Patentee: Kevin L. Parsons, et al.)
)
Patent No.: 6,749,317)
)
Dated: June 15, 2004)
)
Serial No.: 10/045,231)
)
Filed: November 9, 2001)
)
Primary)
Examiner: J. Ward)

REQUEST FOR CERTIFICATE OF CORRECTION

In proofreading the original of the United States Letters Patent 6,749,317, the following printer errors were noted, and the owner of the patent, through his undersigned attorney, respectfully requests issuance of a Certificate of Correction.

Correction to FIG. 2

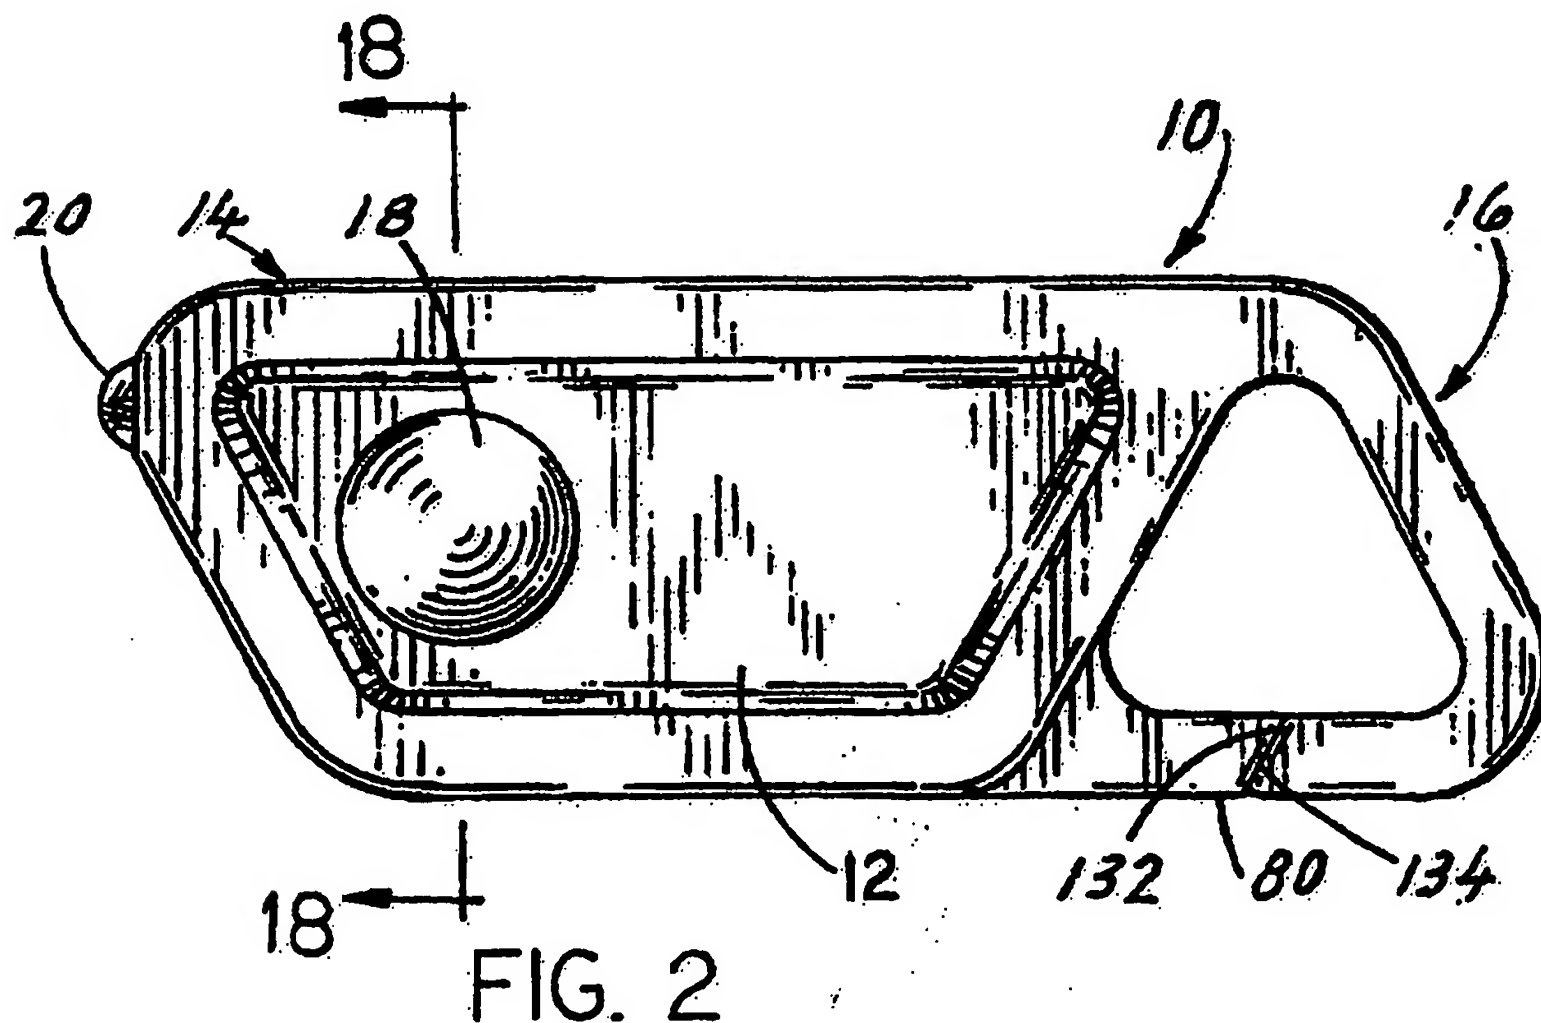
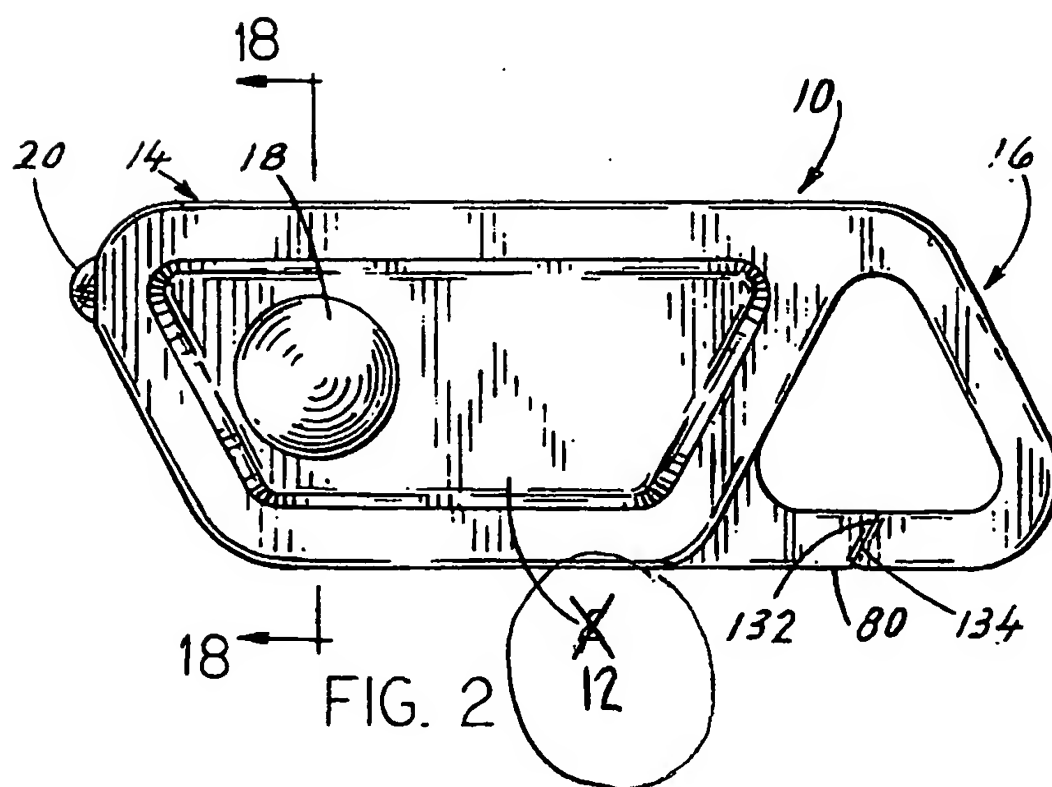
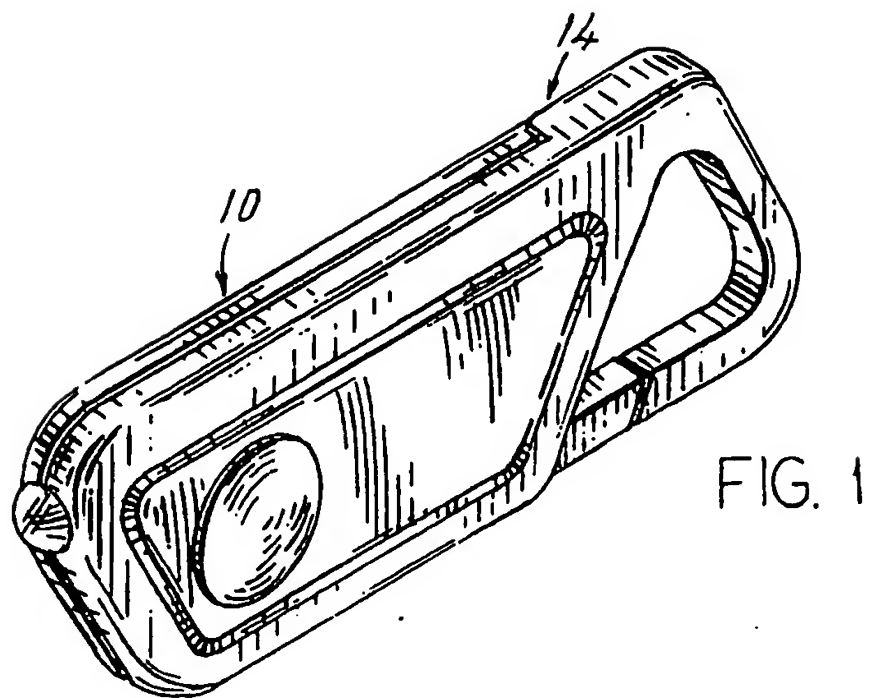
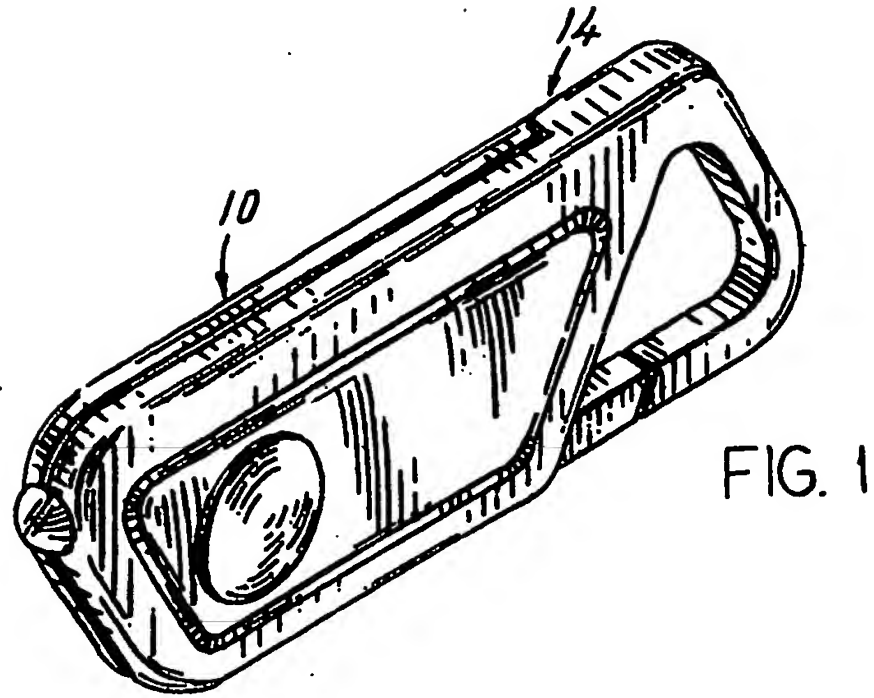
In the drawings, Sheet 1, FIG. 2, the reference numeral "2" should read --12--.

This corrects a typographical error. In the specification, reference numeral 12 refers to "a side cover" while the numeral 2 is not used. As corrected, FIG. 2 should therefore appear as follows:

Correction to FIG. 9

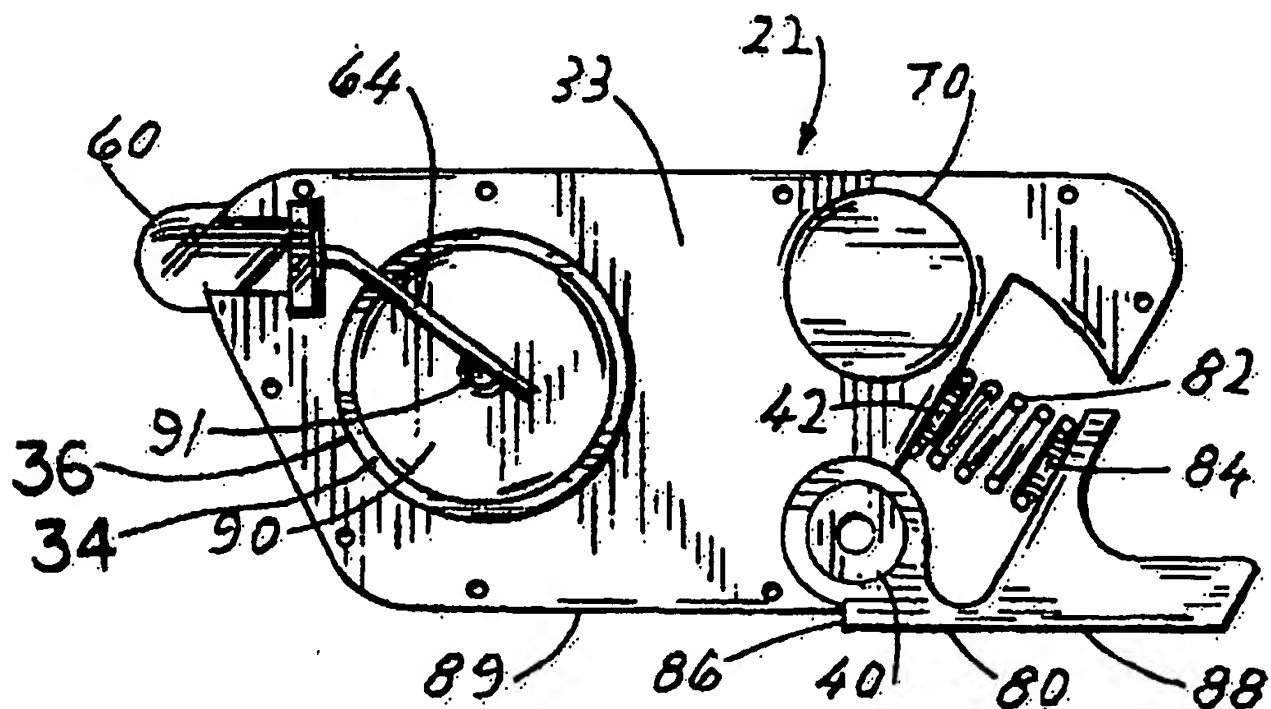
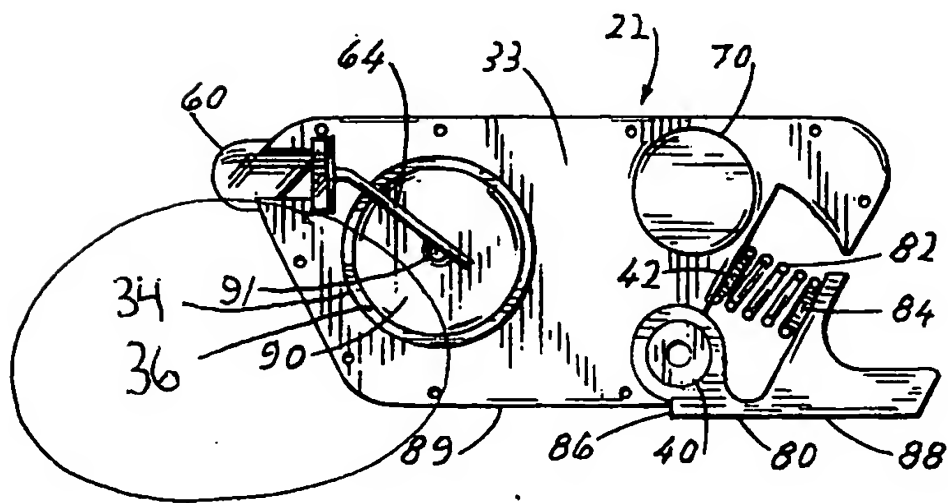
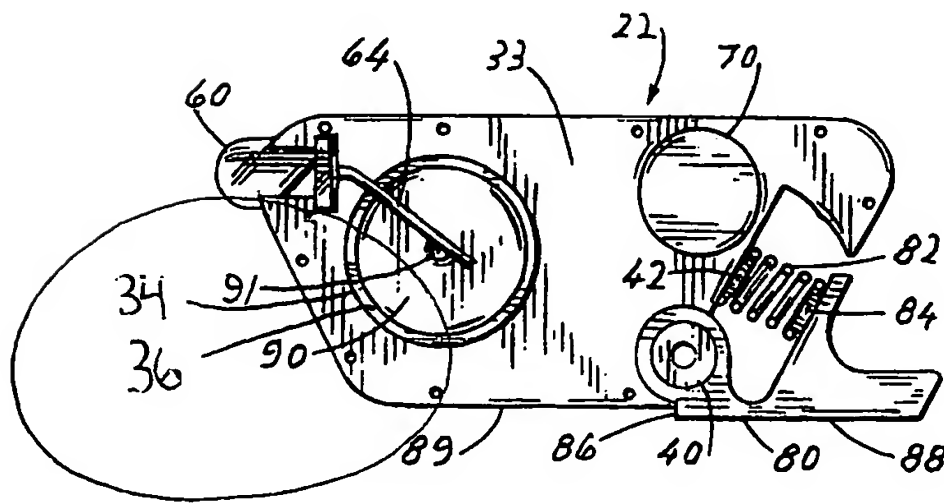
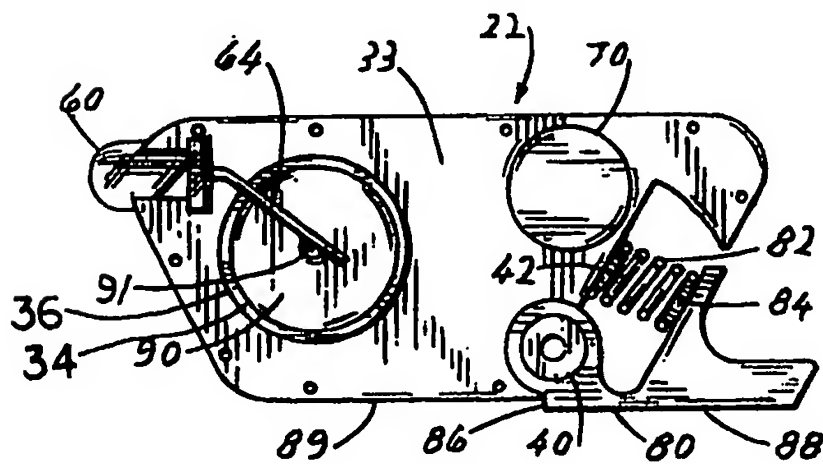
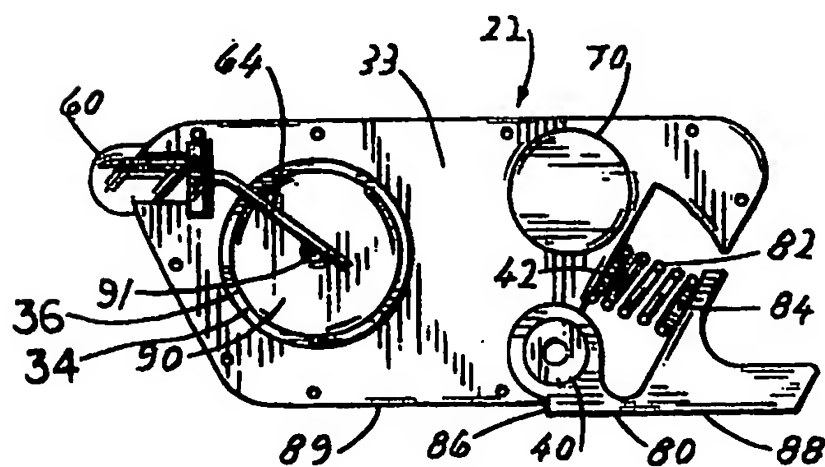
In the drawings, Sheet 3, FIG. 9, the reference numeral 34 and the related lead line should be applied to the counterbore.

In the drawings, Sheet 3, FIG. 9, the reference numeral 36 and related lead line should be applied to the terminus of the counterbore 34.

A portion of the specification that refers to FIG. 9 (see column 9, lines 1-10) identifies a counterbore 34 and a terminus 36. However, the current FIG. 9 does not have these reference numerals or lead lines for them. As corrected, FIG. 9 should therefore appear as follows:
